## **LEWIS ESTATES SUBDIVISION**

APPLICATION NUMBER 2 DATE October 15, 2015

REQUEST Subdivision

## DETAIL SITE PLAN

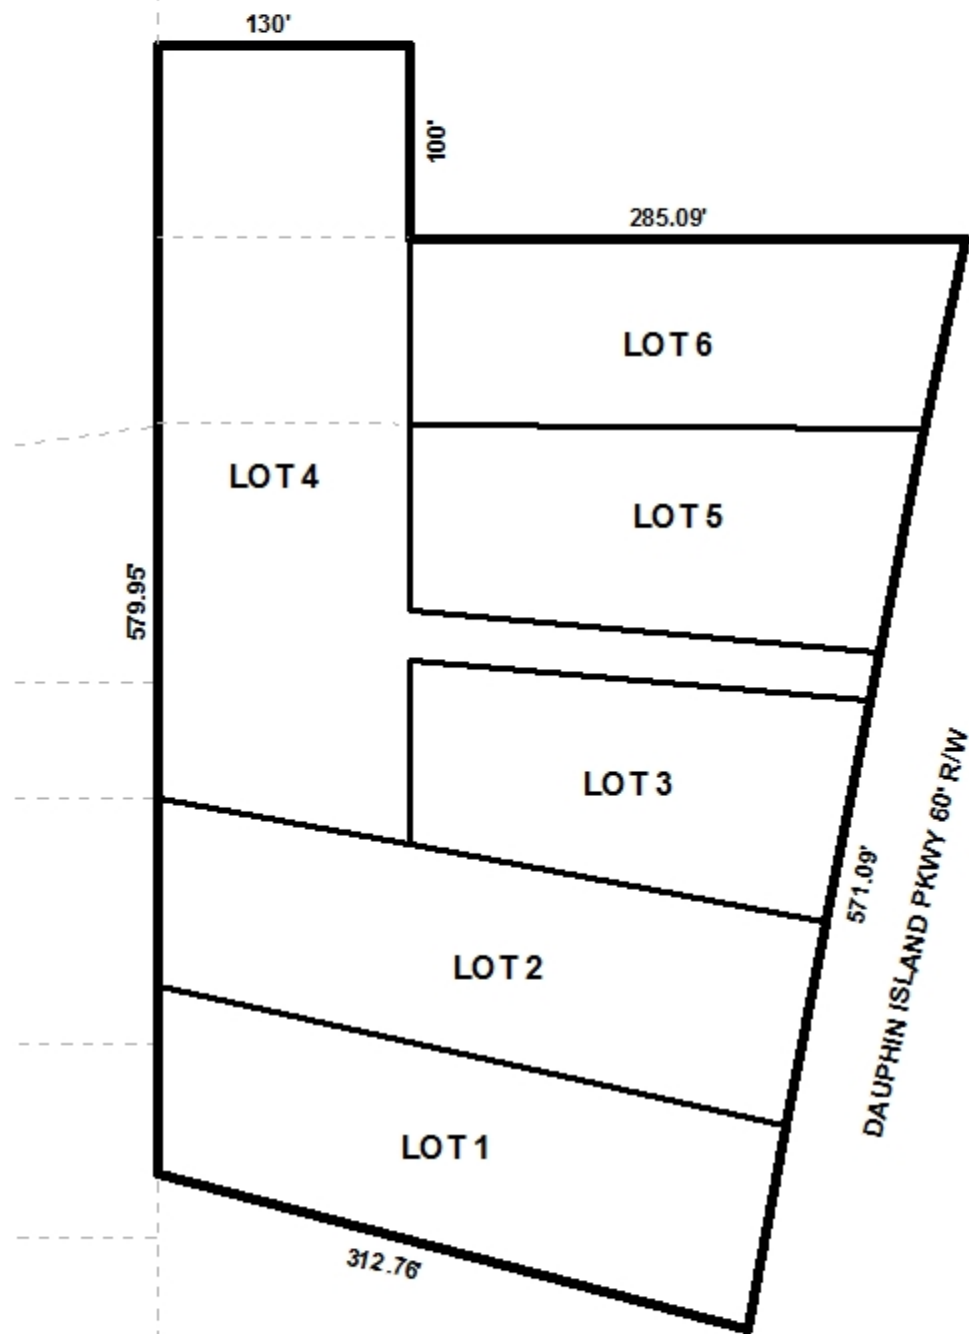
It should be pointed out that the proposed Lot 4 in the current application at hand is irregular in shape and may be considered a flag lot, for which the applicant has also not provided justification, per Section V.D.1. of the Subdivision Regulations.

Ingress/egress for the proposed Lot 4 is planned via the pole portion of the lot which measures 25'± wide by 240'± long. The proposed Lot 4 also abuts an unopened street stub to the west. Due to the limited frontage (25'±) provided, future subdivision of the proposed Lot 4 should be prohibited until additional frontage along a public or private street is provided. This note should appear on the Final Plat, if approved.

In accordance with the Subdivision Regulations, all proposed lots exceed the minimum lot size requirements; however, the 25' minimum building setback line is not depicted on the preliminary plat. If approved, the lot size information and 25' setback should be depicted on the Final Plat. The 25' setback for the proposed Lot 4 should be depicted where the lot is at least 60' wide along the eastern lot line and where the proposed lot abuts the unopened street stub to the west.

The proposed subdivision has frontage along Dauphin Island Parkway, a minor street, adjacent to this site, without curb-and-gutter. No dedication is required at this time as a compliant right-of-way width of 60' is depicted on the preliminary plat, which should be retained on the Final Plat, if approved.

- 1) Justification for the creation of a flag lot, per Section V.D.1. of the Subdivision Regulations;
- 2) Revision of the plat to include the entirety of parcel R023904020002031. as an additional lot, with associated labels, postage and fees; and
- 3) Revision of the plat to depict the required 25' front yard setback. The setback for the proposed Lot 4 should be depicted where the proposed lot is at least 60' wide along the eastern lot line and where the proposed lot abuts the unopened street stub to the west.

- 1) *Placement of a note on the Final Plat stating that future subdivision of Lot 4 is prohibited until additional frontage is provided along a paved, public or private street;*
- 2) *Retention of the lot size information and all setbacks on the Final Plat;*

- 3) *Retention of the 60' right-of-way width notation on the Final Plat;*
- 4) *Placement of a note on the Final Plat stating that each lot is limited to 1 curb-cut each, with the size, design and location to be approved by Mobile County Engineering and conform to AASHTO standards;*
